# MPD Power On State Machine Edits

Michael Paul

- ▶ Fix state machine diagrams
    - Edits on state machine parts A, B, and C
    - Figures 169-6, 169-7, 169-8
  - ▶ Add a timer for inrush
    - Modify subclause 169.5.3.4
    - Modify table 169-8
  - ▶ Add a function for inrush
    - Modify subclause 169.5.3.5
  - ▶ Open-up Mark Event voltage limit
    - Modify table 169-7
- ▶ Add "THEN" to all IF statements
  - ▶ Set present\_discovery\_sig <= TRUE on DO\_MARK1
  - ▶ Set present\_discovery\_sig <= FALSE at PON\_EVAL or IDLE

Figure 169–8—Top level MPD state diagram continued, part c

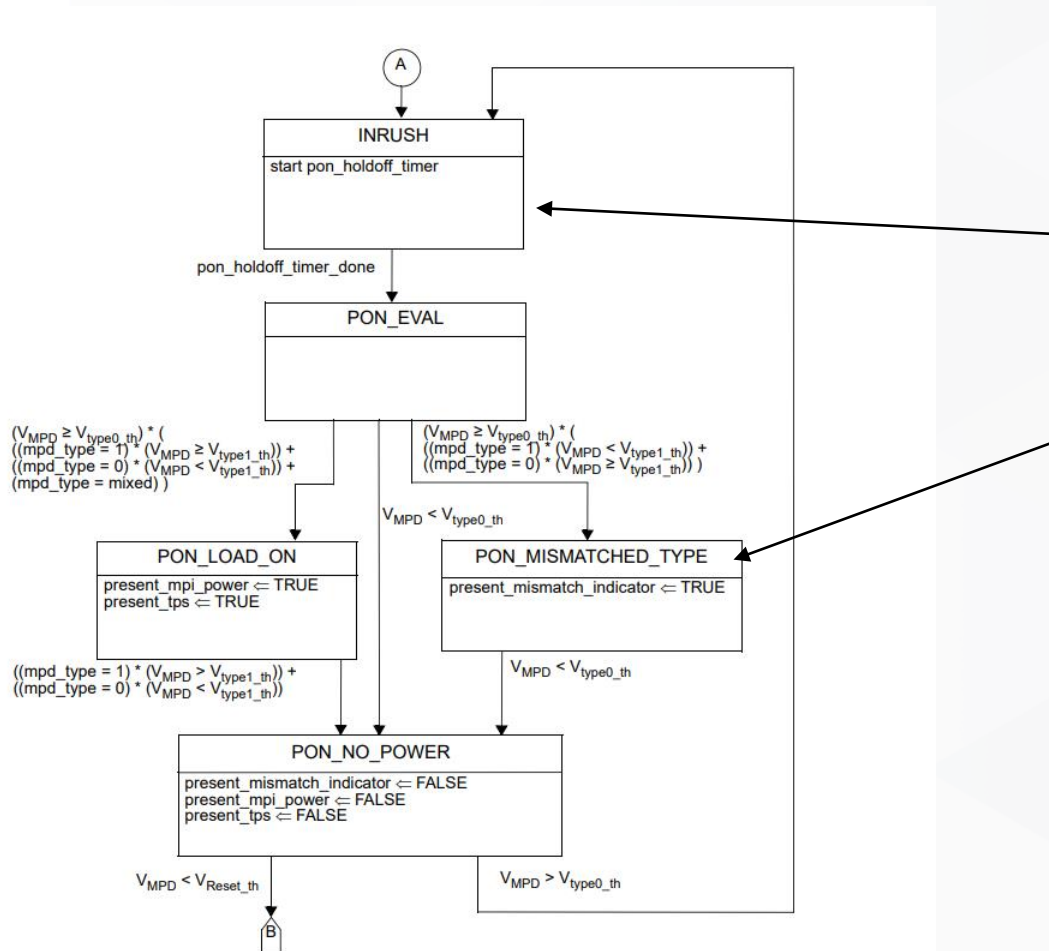
- ▶ INRUSH should only precede states where present\_mpi\_power <= True
- ▶ PON\_MISMATCHED\_TYPE state not needed
  - PON\_MISMATCHED\_TYPE and PON\_NO\_POWER are effectively the same states
  - Both are entered when MPD voltage is not in correct operating region
- ▶ Fix the arc logic

- ▶  $V_{\{On\_MPD\}}$  overlaps mark event voltage
- ▶ Mark and Power On must be differentiated with a timer
- ▶ Existing DO\_MARKx exits do not make sense

# Type 1 MPD States

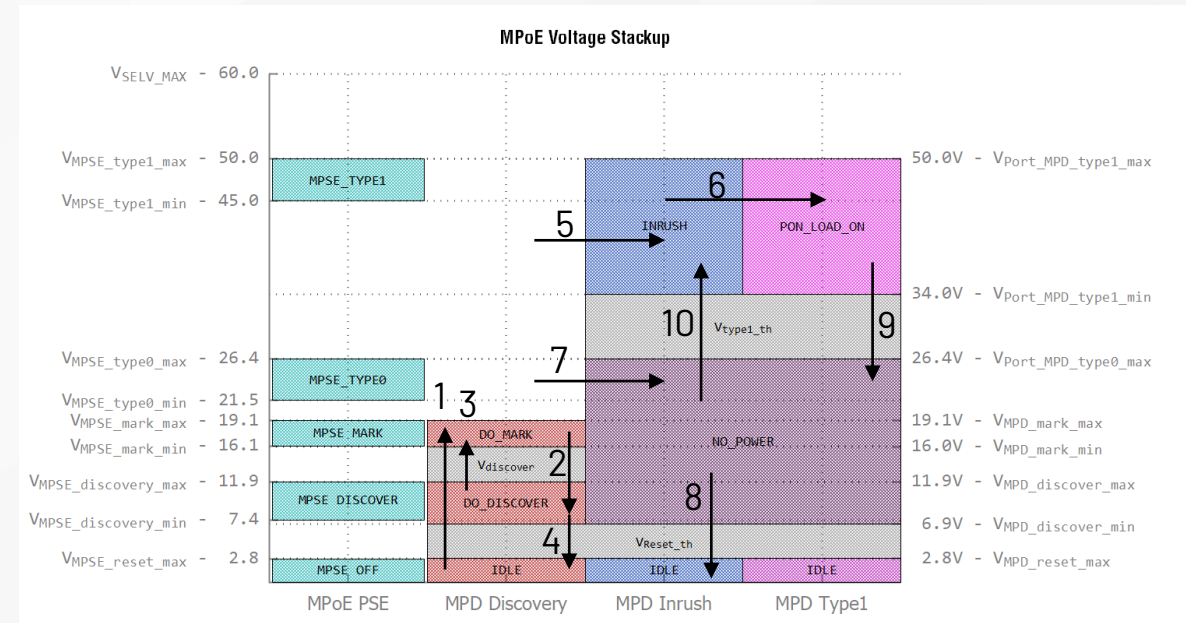
ARC	last state	next state	condition	note
1	IDLE	DO_MARK1	$V_{\{MPD\}} > V_{\{Discovery\_th\}}$	start mark timer needs to be added to state machine
2	DO_MARKx	DO_DISCOVERYx	$V_{\{MPD\}} < V_{\{Discovery\_th\}}$	
3	DO_DISCOVERYx	DO_MARK(x+1)	$V_{\{MPD\}} > V_{\{Discovery\_th\}}$	start mark timer needs to be added to state machine
4	DO_DISCOVERYx	OFFLINE		discovery2 arcs go to IDLE instead of OFFLINE in current state machine? What is the difference between offline and idle
5	MPD_MARKx	INRUSH	$mark\_timer\_done * V_{\{MPD\}} > V_{\{type1\_th\}}$	fix this in state machine, need to go to PON_EVAL 1st, then PON_INRUSH if we are arcing to POWER_ON
6	INRUSH	PON_LOAD_ON	INRUSH COMPLETE - Define Condition	
7	MPD_MARKx	PON_NO_POWER	$mark\_timer\_done * V_{\{MPD\}} < V_{\{type1\_th\}}$	Move through "PON_EVAL" 1st.
8	PON_NO_POWER	IDLE	$V_{\{MPD\}} < V_{\{Reset\_th\}}$	
9	PON_LOAD_ON	PON_NO_POWER	$V_{\{MPD\}} < V_{\{type1\_th\}}$	Consider timing and what happens at PI vs. behind recitifer and bulk caps. PI voltage and internal voltage can get out of sync

10	PON_NO_POWER	PON_LOAD_ON	$V_{\{MPD\}} > V_{\{type1\_th\}}$	Any timing or hysteresis requirements to stop a 10-6-9 loop?

# Type 0 MPD States

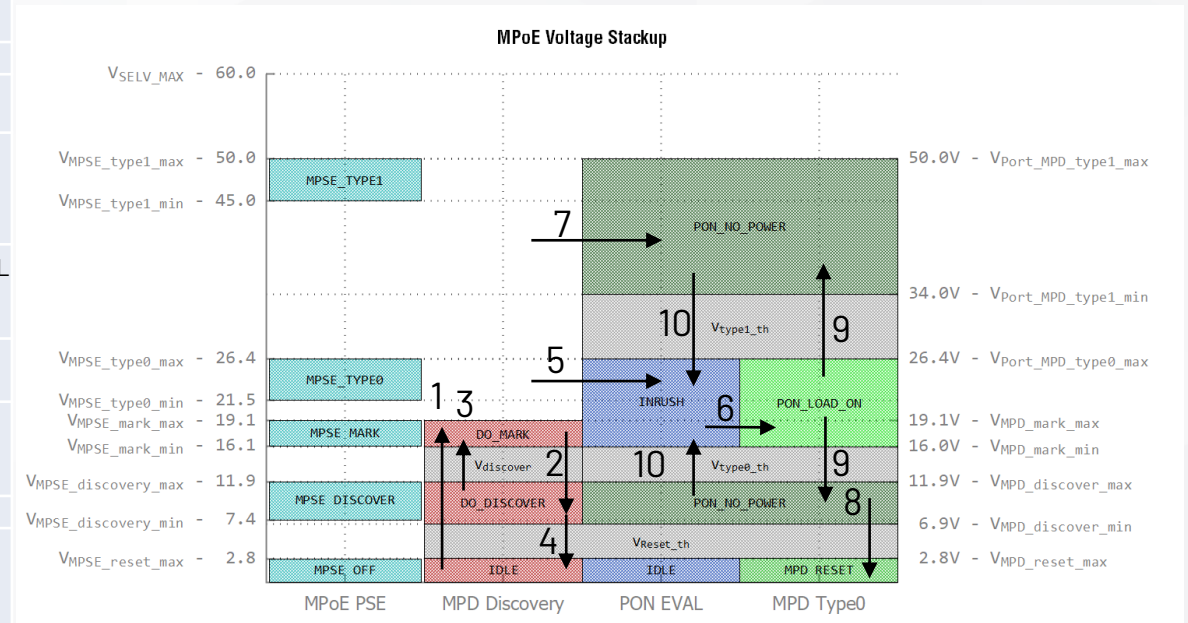
ARC	last state	next state	condition	note
1	IDLE	DO_MARK1	$V_{\{MPD\}} > V_{\{Discovery\_th\}}$	start mark timer needs to be added to state machine
2	DO_MARKx	DO_DISCOVERYx	$V_{\{MPD\}} < V_{\{Discovery\_th\}}$	
3	DO_DISCOVERYx	DO_MARK(x+1)	$V_{\{MPD\}} > V_{\{Discovery\_th\}}$	start mark timer needs to be added to state machine
4	DO_DISCOVERYx	IDLE		Discovery arcs go to IDLE instead of OFFLINE in current state machine? What is the difference between offline and idle
5	MPD_MARKx	INRUSH	mark_timer_done * $V_{\{MPD\}} > V_{\{type0\_th\}}$ * $V_{\{MPD\}} < V_{\{type1\_th\}}$	fix this in state machine, need to go to PON_EVAL 1st, then PON_INRUSH if we are arcing to POWER_ON
6	INRUSH	PON_LOAD_ON	INRUSH COMPLETE - Define Condition	
7	MPD_MARKx	PON_NO_POWER	mark_timer_done * $V_{\{MPD\}} < V_{\{type0\_th\}} + V_{\{MPD\}} > V_{\{type1\_th\}}$	Move through "PON_EVAL" 1st
8	PON_NO_POWER	IDLE	$V_{\{MPD\}} < V_{\{Reset\_th\}}$

9	PON_LOAD_ON	PON_NO_POWER	$V_{\{MPD\}} < V_{\{type0\_th\}} + V_{\{MPD\}} > V_{\{type1\_th\}}$	Consider timing and what happens at PI vs. behind rectifier and bulk caps. PI voltage and internal voltage can get out of sync
10	PON_NO_POWER	PON_LOAD_ON	$V_{\{MPD\}} > V_{\{type0\_th\}}$ * $V_{\{MPD\}} < V_{\{type0\_th\}}$	Any timing or hysteresis requirements to stop a 10-6-9 loop?

Figure 169-6—Top level MPD state diagram, part a

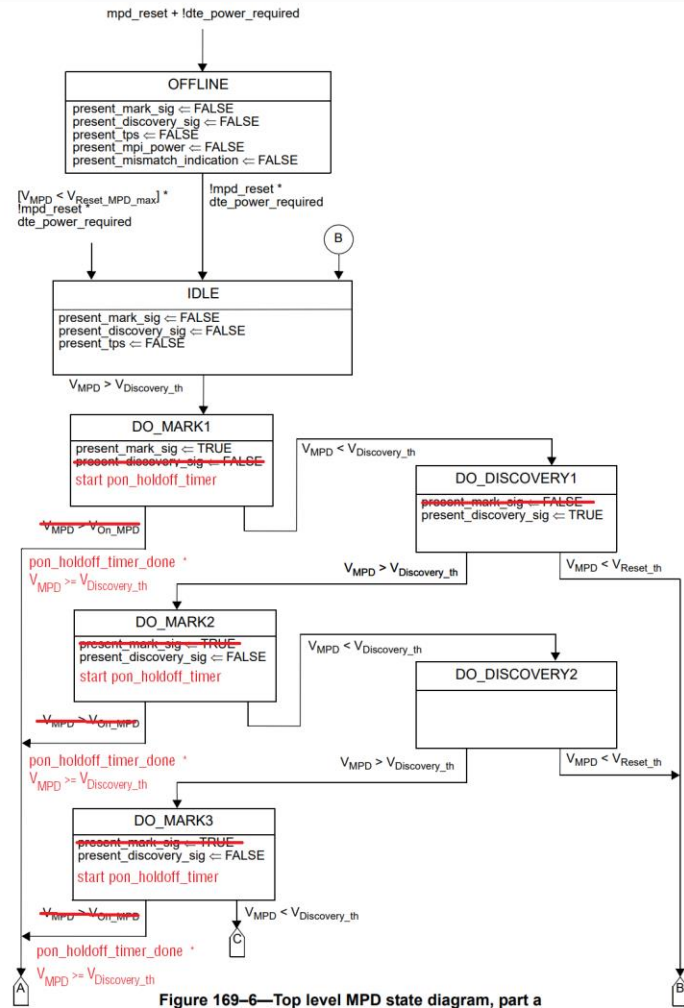
- ▶ PON\_EVAL simplifies arc logic out of the discovery state machine
  - Set 'present\_mark\_sig' <= FALSE
- ▶ INRUSH only precedes PON\_LOAD\_ON
- ▶ PON\_NO\_POWER handles all conditions where MPD type and MPD voltage are mismatched
